Auckland Transport  
Attention: Jonathan Levell, Scott Ebbett, Alok Vashista  
15 Jan 2018

## FEEDBACK ON PHASE 2, PARKING CHANGES, THE STRAND, PARNELL

45° Angle Parking (Designated to cult/crestline)

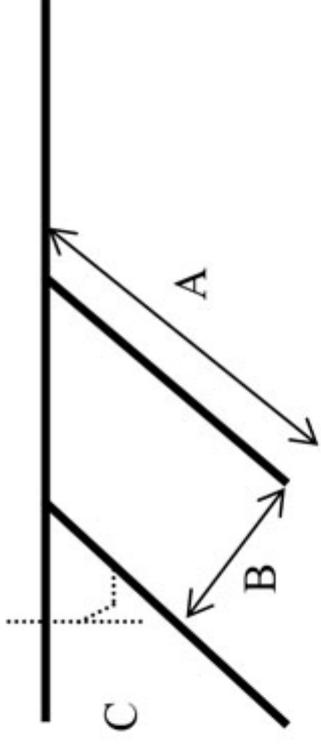
One of the businesses has tabled an alternative suggestion which is attached. They make the point that backing out of an angle park outside 73 is less dangerous than trying to back into a Parallel park right on the bend – which we agree with. It might have to be 30 degree angled parks instead of 45 degree. Please can AT respond to this query.

This layout from experience is safer than the parallel parking on the corner. The road outside 73 is wider than further along the strand towards shipwreck lane. Ample room for 4-angle parks outside.
